ISSUES CTB1-01 / 02 | AS1 AWNING STRUT

FINSBURY GREEN FACILITY

Diagonal Brace DETAILS

CTB1

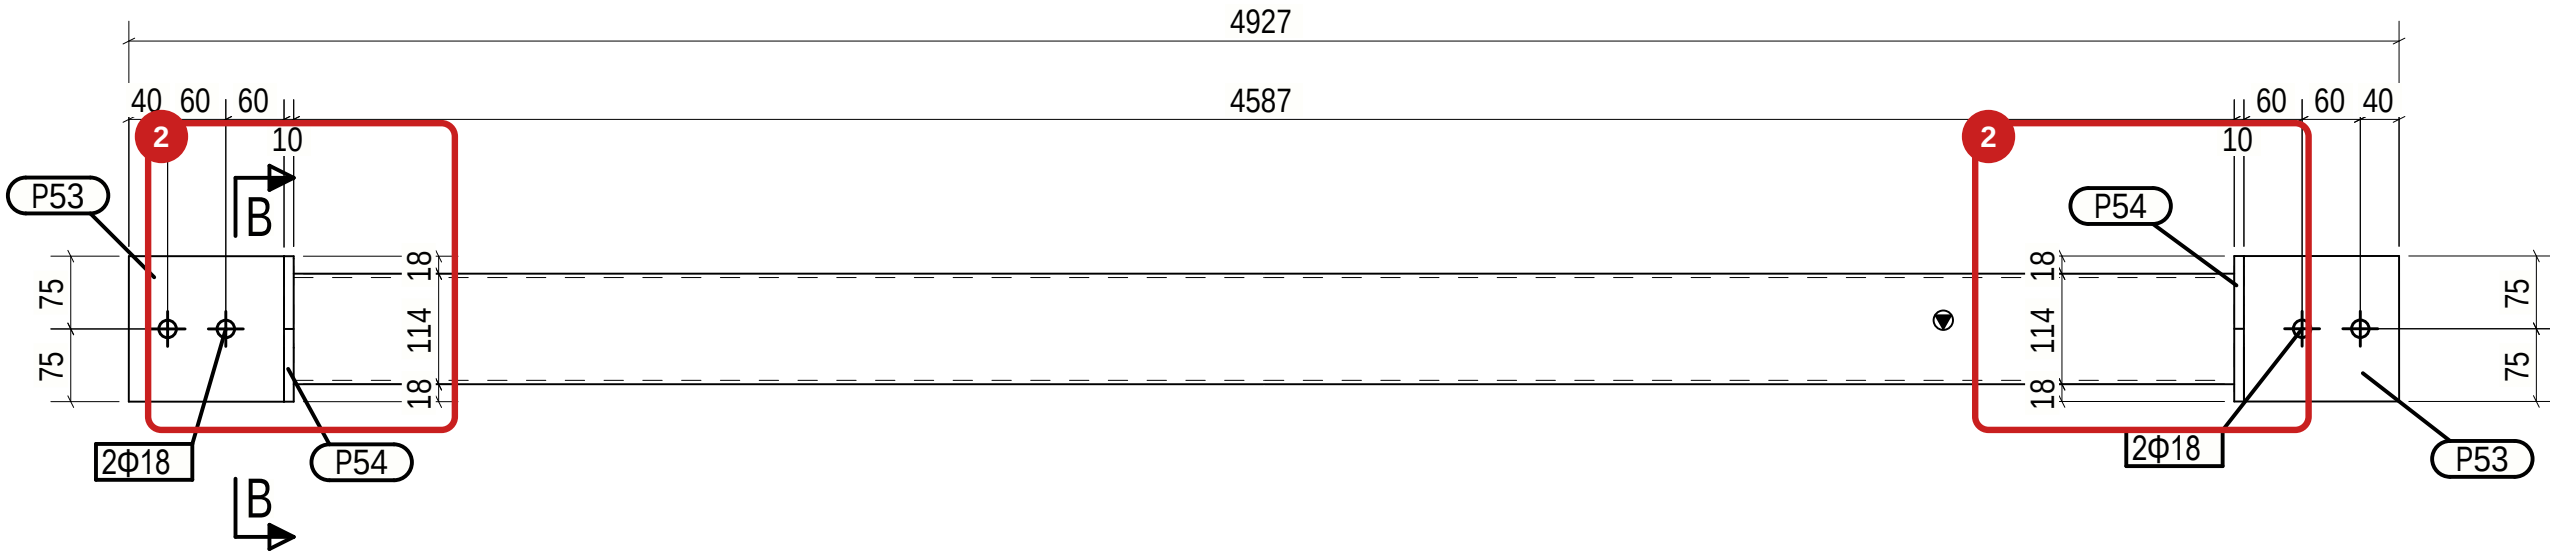
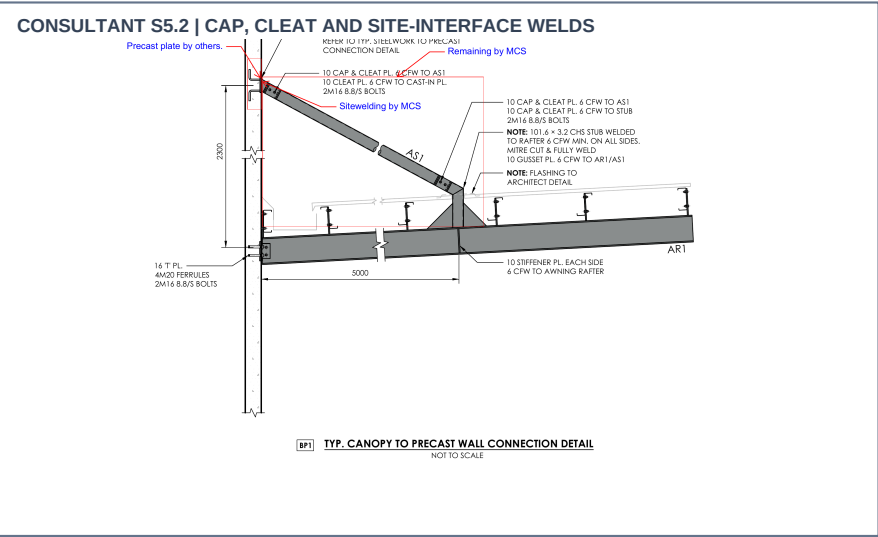
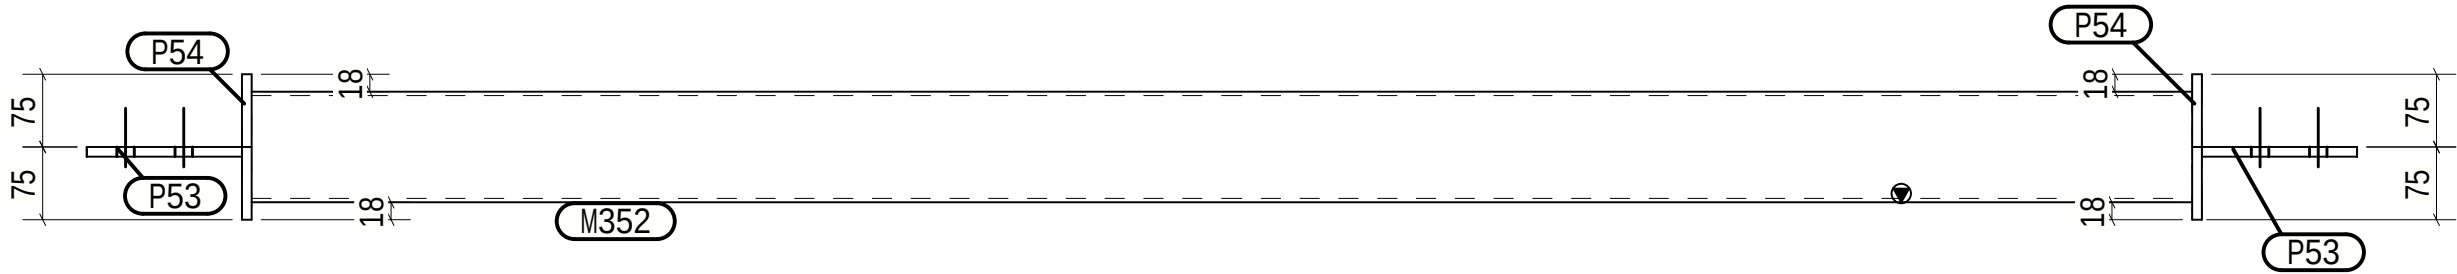
- P54 solid end caps close the CHS114x4 member; no HDG vent/drain holes or approved alternative are shown.
- Consultant S5.2 cap/cleat and site-interface weld requirements are not explicitly located or defined on CTB1.

ACTION: add galvanizing vent/drain strategy and explicit shop/site weld callouts at both end interfaces.
